Access Compliance Report

Public Rights-of-Way

(Curb Ramps)

Intersection ID: 17742	Main Street: S_WENDOVER_RD	Cross Street: PROVIDENCE_RD	Location: S
ADA ID: ECEC93647CD7	Ramp Type: PerpDiag	Initial Pass/Fail: Fail	Overall Compliance: No
Severity Score: 13.75			
Codes/Mitigation Info/Possible Solution		Field Measurements/Component Compliance

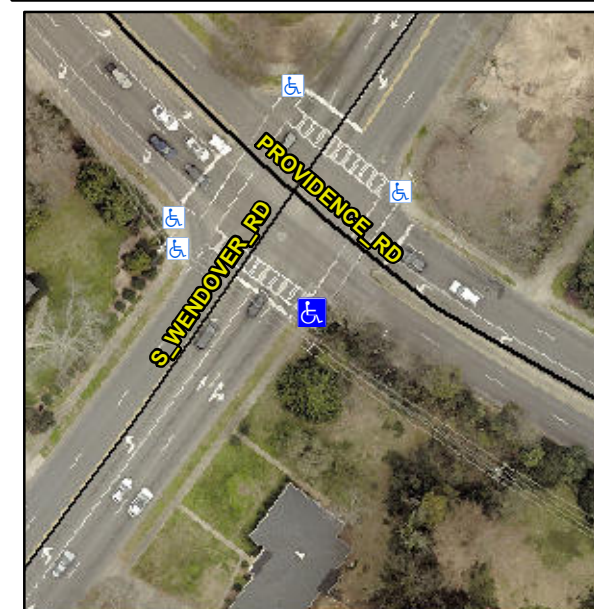
Not Found, R304.2.2, R304.5.3

Compliance	Description	Data	Compliance	Description	Data
N/A	Ramp Length (in)	55.5	No	Ramp Slope (%)	8.4
Yes	Ramp Width (in)	48.0	No	Ramp XSlope (%)	4.7
N/A	Flare Type LT	N/A	N/A	Flare Type RT	N/A
N/A	Flare Slope LT (%)	N/A	N/A	Flare Slope RT (%)	N/A
N/A	Flare Traversable LT?	N/A	N/A	Flare Traversable RT?	N/A
N/A	Landing Length (in)	N/A	N/A	DWS Provided?	N/A
N/A	Landing Width (in)	N/A	N/A	DWS Contrast?	N/A
N/A	Landing Slope (%)	N/A	N/A	DWS Length (in)	N/A
N/A	Landing X Slope (%)	N/A	N/A	DWS Full Width?	N/A
N/A	Landing Curb? (Y/N)	N/A	N/A	DWS Offset (in)	N/A
N/A	Shared Landing?	N/A			
N/A	Gutter Ponding?	N/A	N/A	Gutter Slope (%)	N/A
N/A	Gutter Lip Ht (in)	N/A	N/A	Gutter X Slope (%)	N/A
N/A	Painted X Walk1?	Yes	N/A	Painted X Walk2?	Yes
	X Walk 1 Direction	To NE		X Walk 2 Direction	To NW
N/A	X Walk 1 Width (in)	100.0	N/A	X Walk 2 Width (in)	108.0
	X Walk 1 Slope (%)	6.6		X Walk 2 Slope (%)	1.5
	X Walk 1 X Slope (%)	1.7		X Walk 2 X Slope (%)	5.1

N/A	Ramp inside XWalk1?	Yes	N/A	Ramp inside XWalk2?	Yes
	Road Slope (%)	2.5	N/A	Clear Space?	N/A
	Road X Slope (%)	6.4	N/A	Clear Space to XWalk (in)	N/A
N/A	Any Obstructions?	N/A	N/A	Storm Grate/Utility Hazard?	N/A
	Obstruction Type			Storm Grate/Utility Type	
		N/A			N/A
		Yes		Surface Condition? (G/P)	Good

Remove & Replace Curb Ramp With Two New Directional Ramps or Equivalent.
